CITY OF ALBUQUERQUE

RE: **Lot 15, Blk 1 Cliffs Unit 22 SAD 228**
8009 Agua Fria Ct. NW
Grading and Drainage Plan
Engineers Stamp Date 10/29/2020 (D10D003N15)
Pad Certification Date: 3/11/2021

SHEET TITLE: GRADING AND DRAINAGE PLAN

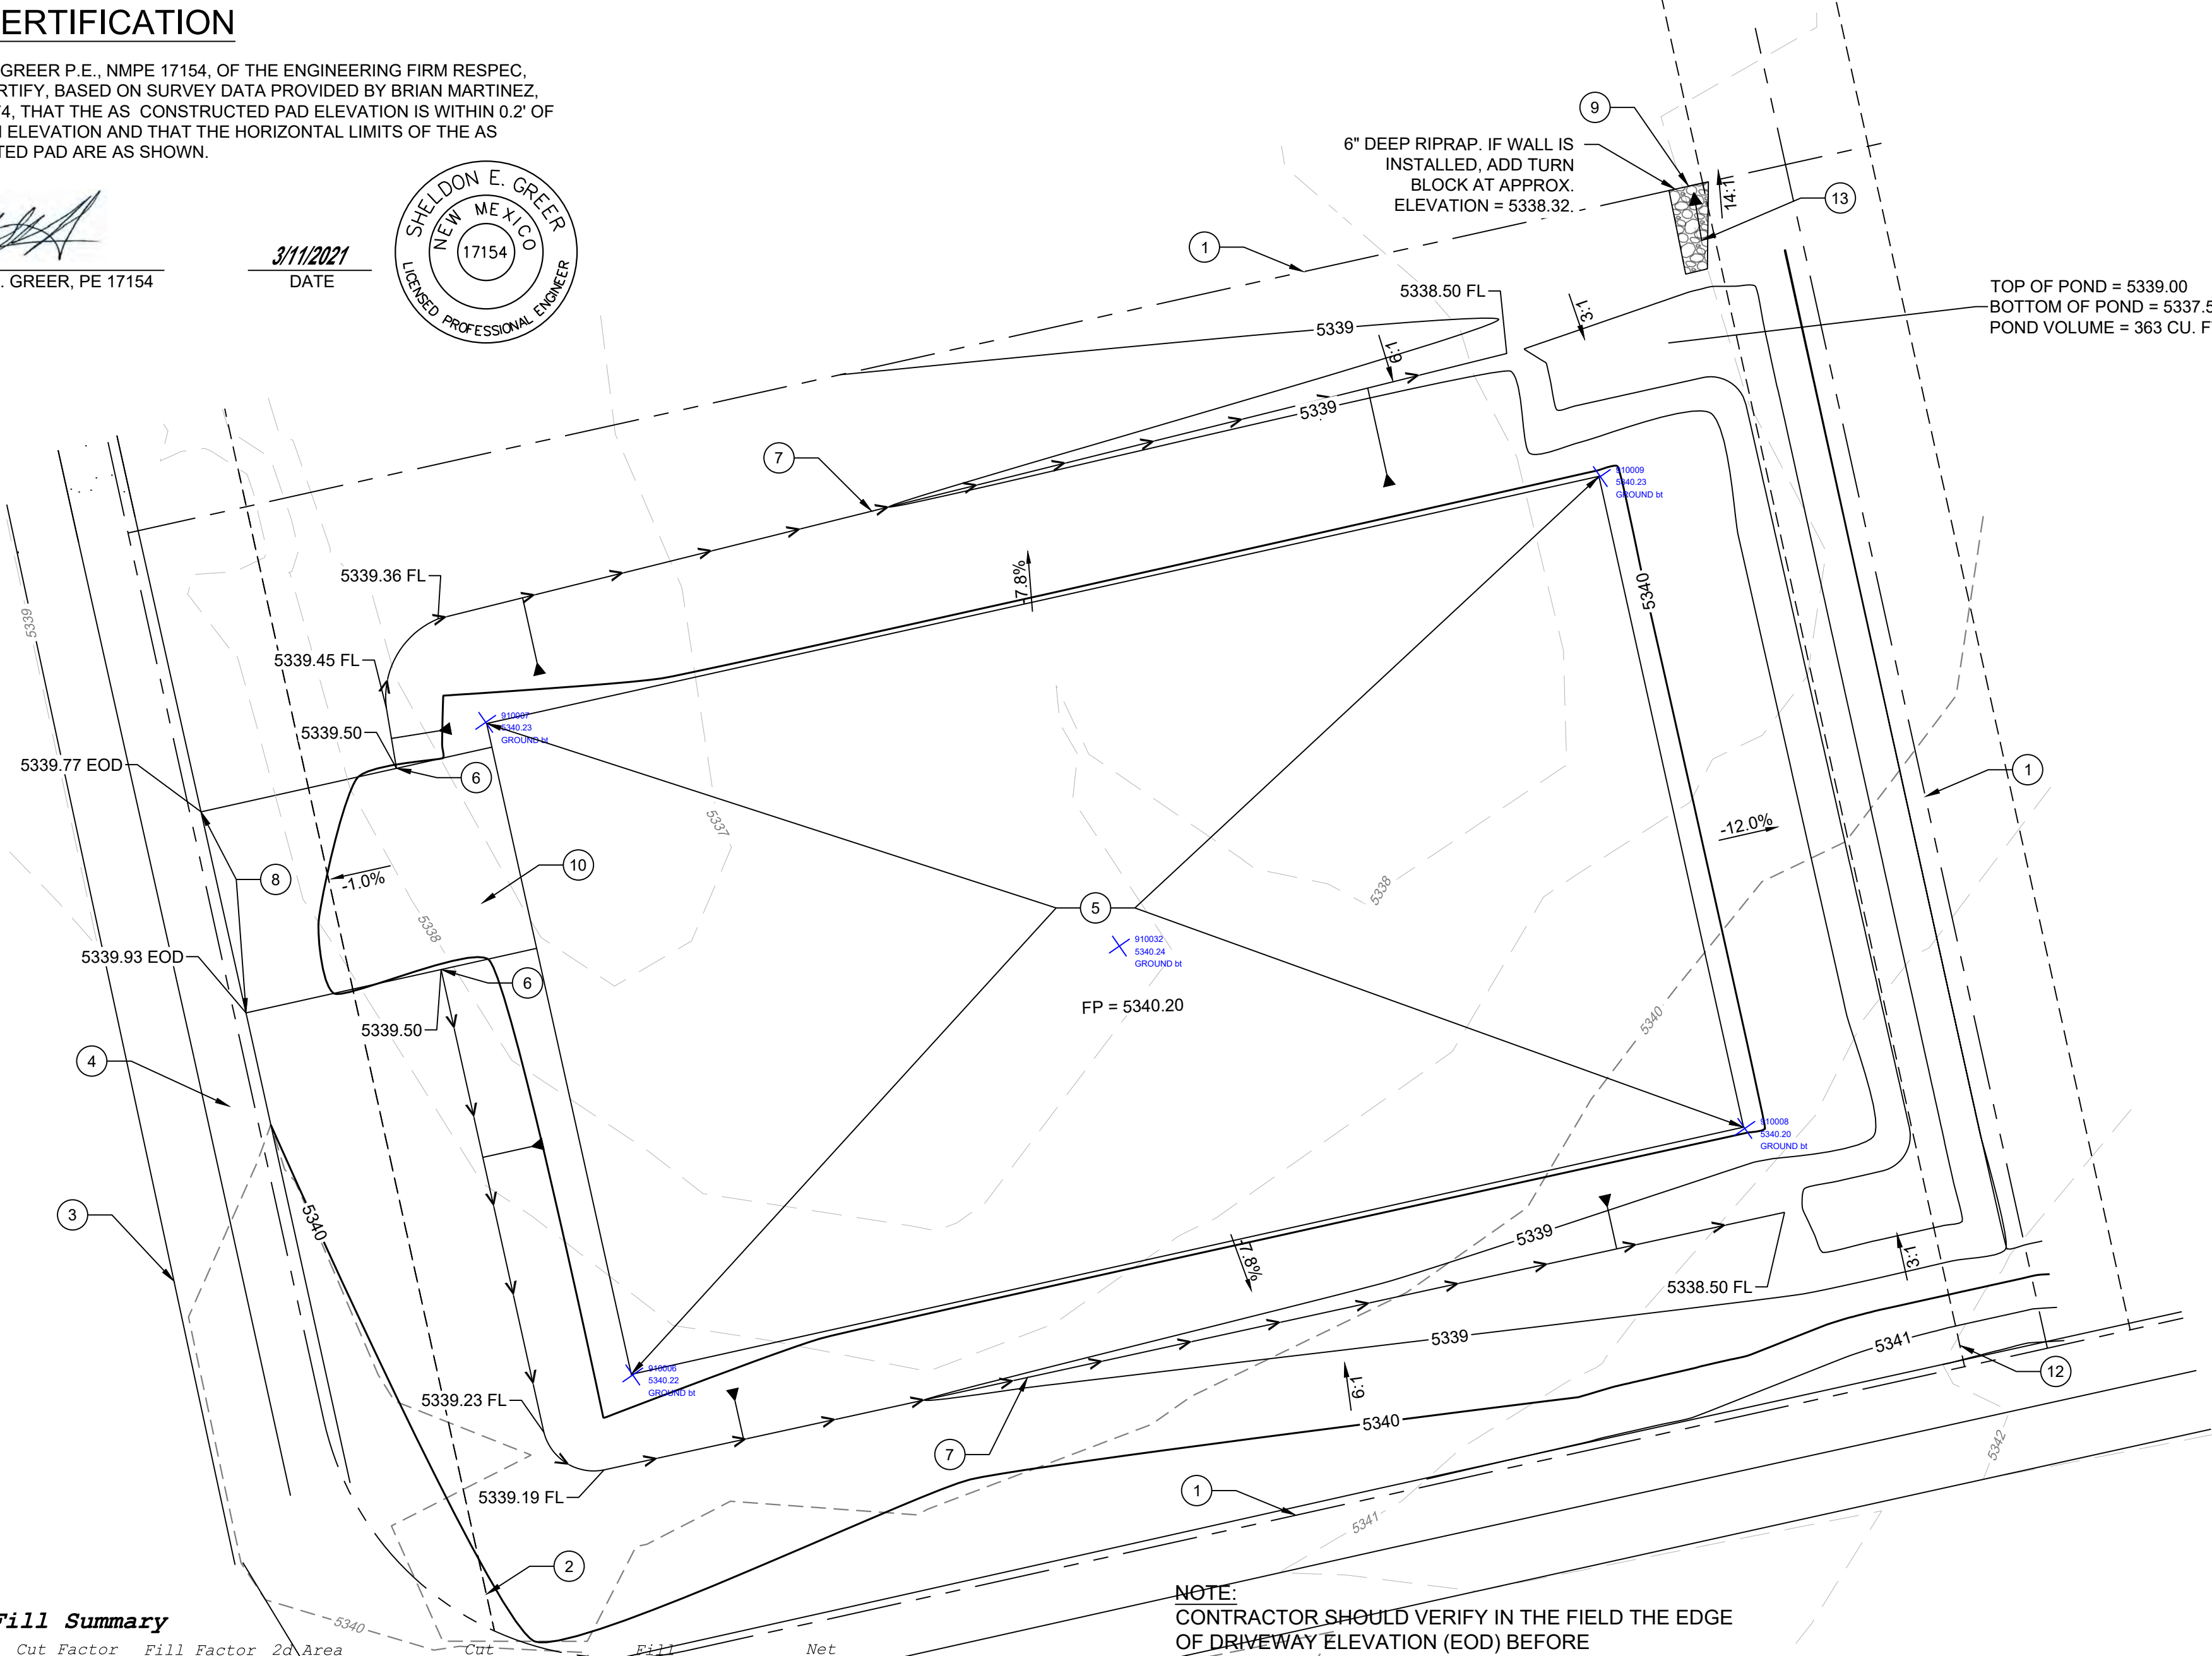
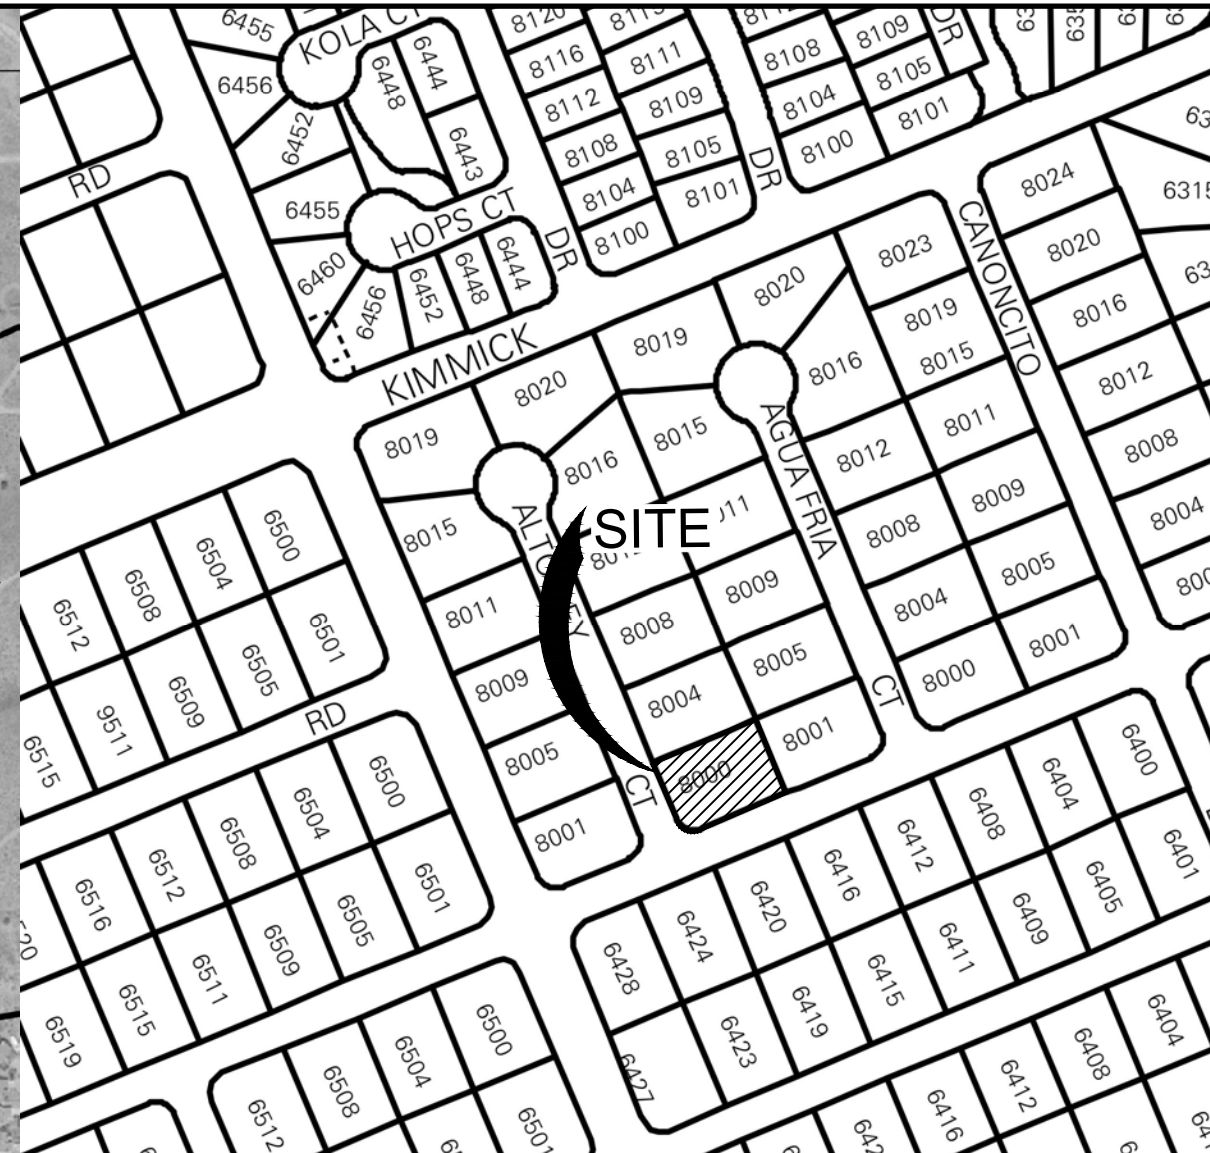
Prior to Building permit approval a Pad Certification will be required, provided by the Engineer or a registered Land Surveyor.

Reiterate to the Owner/Contractor that a separate permit for a garden/retaining wall must be obtained with the approved G&D plan and Pad Certification. **Also, if a swimming pool is to be placed the grading and drainage plan will change and will need to be resubmitted.**

Prior to Certificate of Occupancy release, Engineer Certification per the DPM checklist will be required.
